Project: IEEE P802.15 Working Group for Wireless Personal Area Networks (WPANs)

Submission Title: [LB50 comment resolution related to subclause 5.6.5]

Re: [Response to LB50 comments]

LB50 comment resolution related to subclause 5.6.5

CID 180, 181

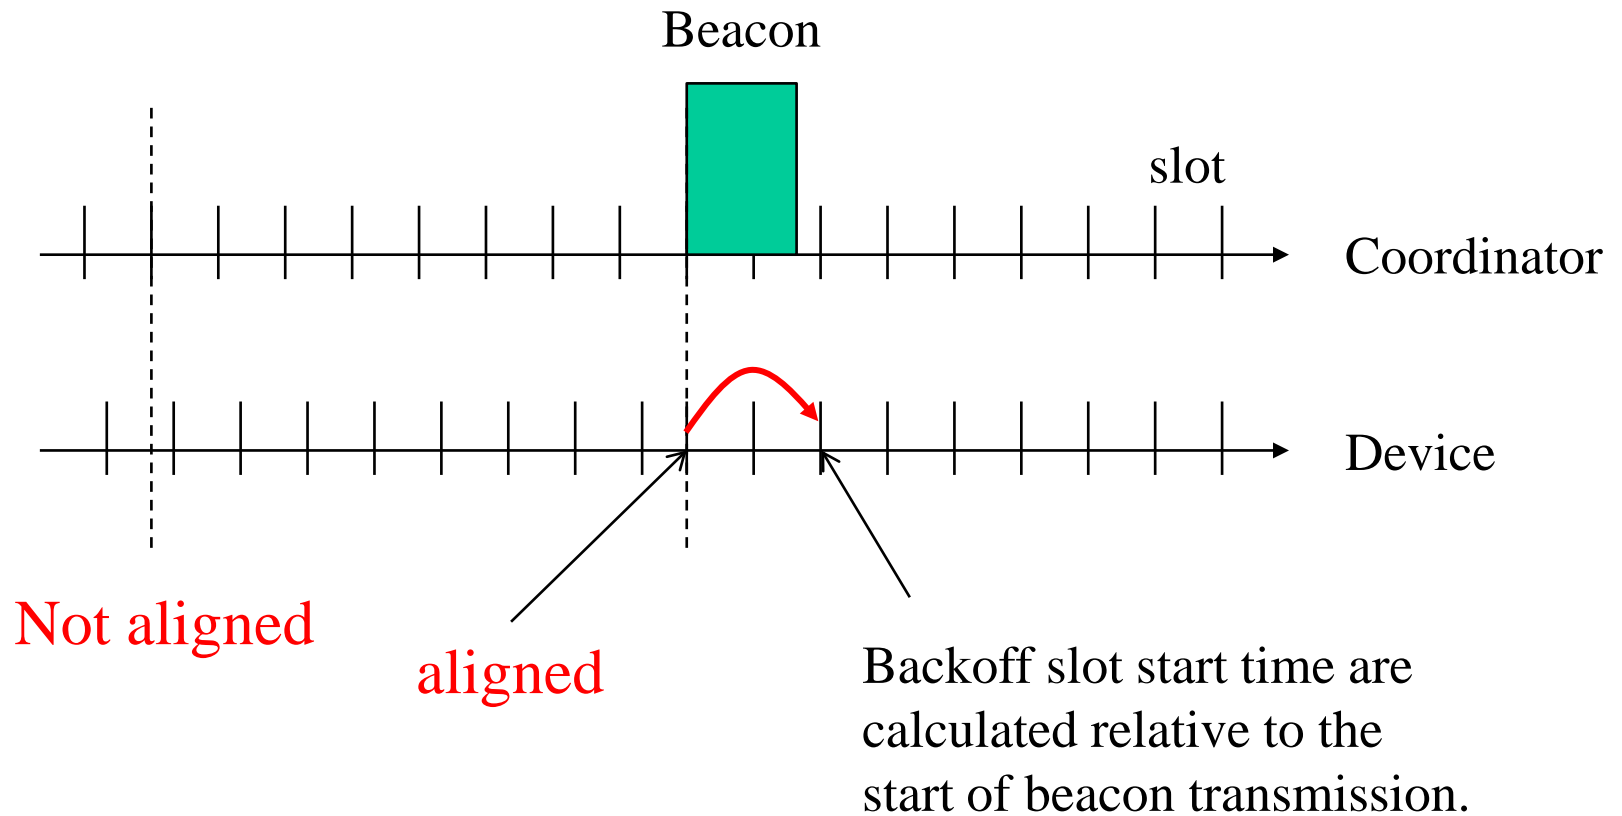
CID	Name	Clause	Subclause	Page	Line	Comment	Suggested Remedy
180	James Gilb	5	5.6.5.1	18	23	"Non beacon ... in 7.6.1.5" is not correct. They can use either Aloha or CSMA/CA (the correct names).	Just say that either can be used. Better still, list the 4 methods by the correct name in a dashed list, cross reference the section (7.6.1.5) and delete the rest of this subclause.
181	James Gilb	5	5.6.5.1	18	31	"Beacon-enabled ... beacon transmission." is not correct as they can use either slotted aloha or slotted CSMA/CA (the correct names).	Just say that either can be used. Better still, list the 4 methods by the correct name in a dashed list, cross reference the section (7.6.1.5) and delete the rest of this subclause.

- Resolution/Instruction to editor
 - Accept in principle, see CID 133
